# Travis County Commissioners Court Agenda Request

February 12, 2013

In Basic Development Permit Application #12-1748, Lake Travis ISD proposes to develop a 32.46 acre tract at 4932 Bee Creek Road, in the City of Lakeway ETJ, to construct the New Middle School, including associated drives, sports fields, utilities, water quality controls, and detention structures. The proposal is subject to the development permitting requirements of Travis County and City of Lakeway. The tract for the school site generally wraps around the top of a hill with steep slopes facing west and downhill to a tributary of Bee Creek. Approximately 27% of the site has slopes greater than 15%. The site consists of mixed grasses and dense wooded areas adjacent to a horse farm. The applicant requests two variances to allow the preferred development configuration in spite of the topographic challenges of the site. The applicant also requests a variance from fiscal security requirements.

**WATERWAY SETBACK DIAGRAM**

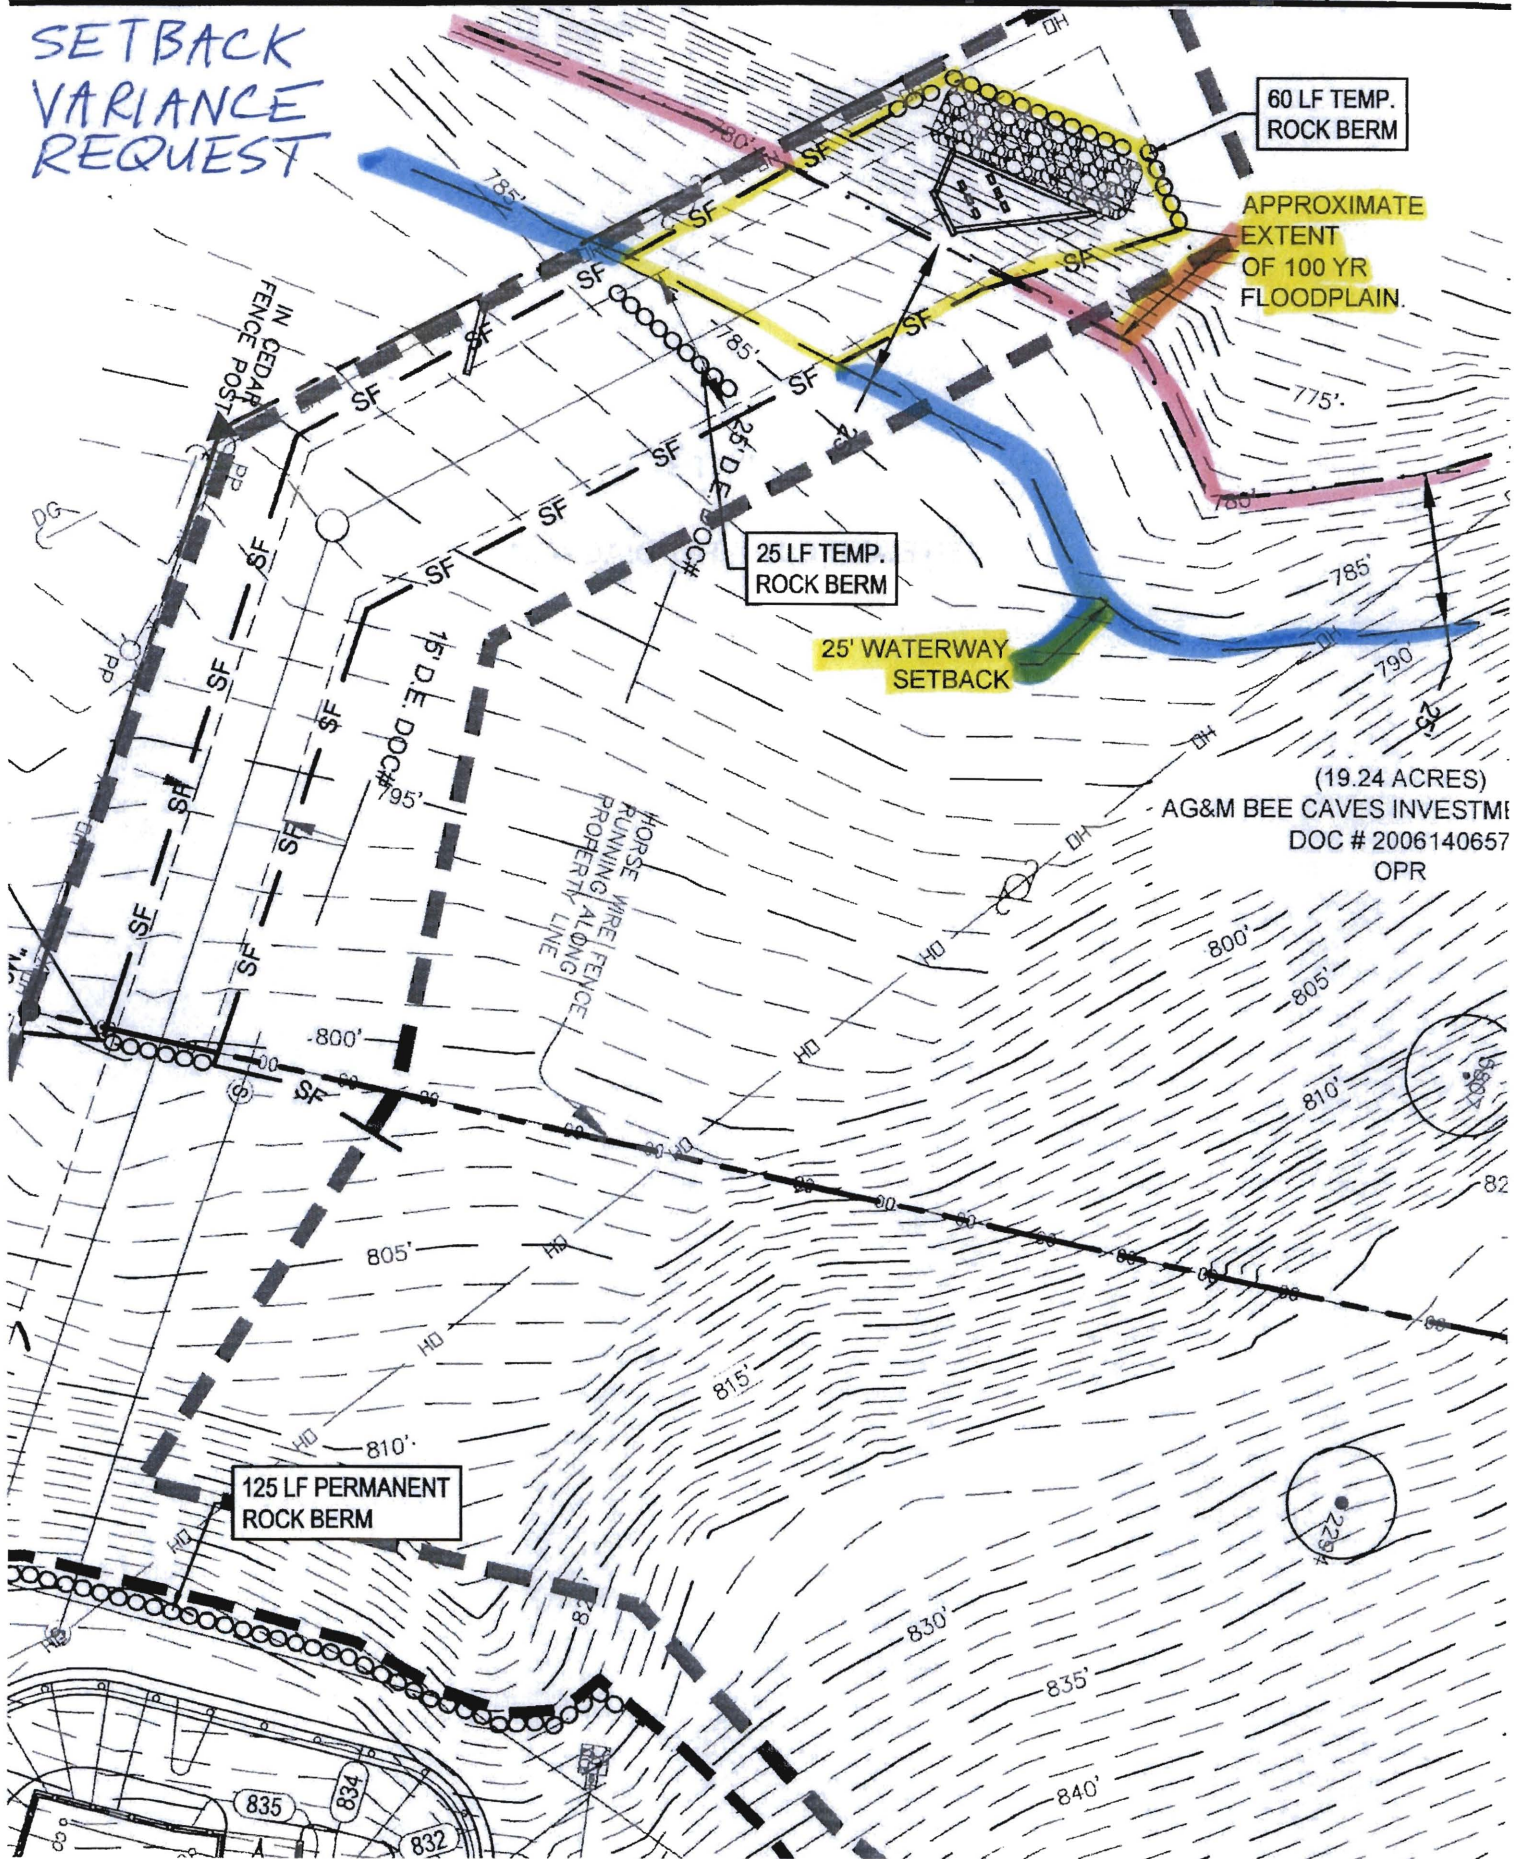
Staff recommend approval of Variance A. Lake Travis ISD proposes placement of a storm sewer outlet headwall within the waterway setback in a drainage easement granted by the adjacent property owner (See Exhibit 2). Staff agrees with the applicant that the encroachment into the setback would allow for more certain compliance with Section 82.941(i) at significantly less cost while significantly dissipating the velocity and energy of the flow at the outlet point. While the variance is caused by the method chosen by the applicant, the staff believe the location of the storm sewer outlet below the steep slope will achieve greater environmental protection and reduces the probability of soil erosion and harmful environmental consequences than if the storm sewer discharged above the steep slope and outside of the waterway setback. Staff also have determined that the applicant's variance request is a method that makes minimal alteration of the waterway setback area (affected area equals 1821 sq. ft. or 0.041 acre), includes sufficient erosion and stabilization controls while construction of the storm sewer occurs.

The attached storm sewer plan shows the proposed alignment of the storm sewer line and the proposed headwall construction within the Waterway Setback (indicated thereon as a 25' setback from the approximate 100-yr floodplain). Our design entails the construction of a 36" concrete headwall/stilling basin at the base of the existing stream bank with a large rock splash pad in the stream bottom. We've estimated the cost to construct this headwall/stilling basin at approximately \$12,000, the large rock splash pad at \$1500, and additional 36" storm sewer line constructed within the waterway setback at approximately \$12,500 for a total estimated cost for the work within the setback at \$26,000.

**SITE AND CUT & FILL DIAGRAM**

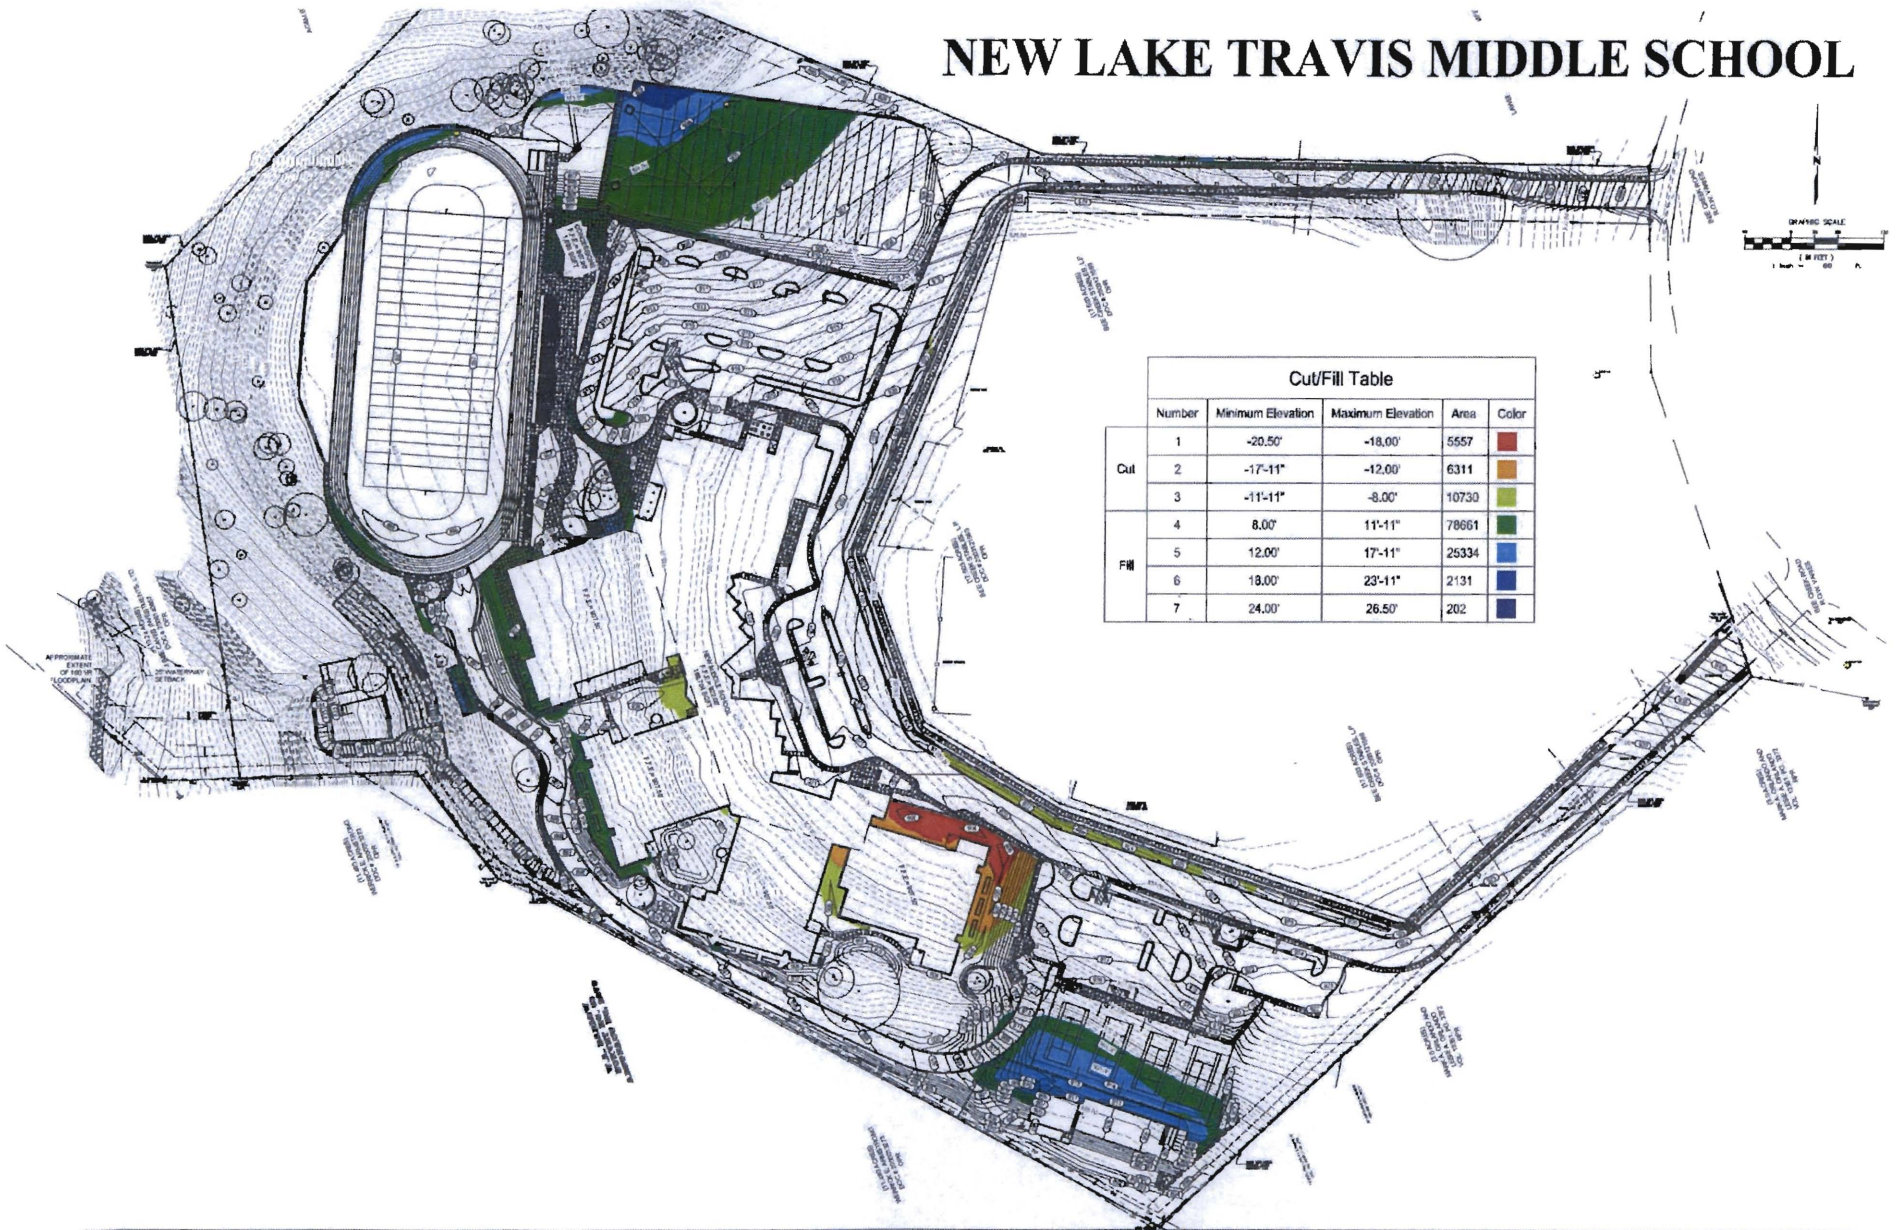
Staff recommend approval of Variance B. Lake Travis ISD proposes placement of land balancing cuts totaling 0.519 acres and fill placement totaling 2.441 acres. Exhibit 3 shows the specific locations proposed for the cut/fill. Staff agrees with the applicant that cuts and fills exceeding eight feet are important in order for design a functional site that provides educational services on this topographically challenging location. Without the variance, all athletic functions would not be possible and the practice and competition fields would need to be limited due to the topography. The applicant notes that the amount of cut/fill is minimized due to the school design of a split level building, use of terraced retaining walls, and placement of 73% of the facility on slopes of less than 15%, more closely following the natural terrain.

The attached exhibit shows the proposed site and grading plan and delineates in different colors cut/fill areas ranging from 8' to 11'-11", 12' to 17'-11", 18' to 23'-11", and 24' and greater.

2. It is not feasible to fully comply with the requirements of Sec. 82.943(a) while accommodating all of the educational programs and athletic functions required for a middle school. At a minimum, full compliance would require the elimination of the practice and competition fields (areas 'A', 'B', 'C' and 'D') due to the size of their respective footprints, and the natural topography in these areas.
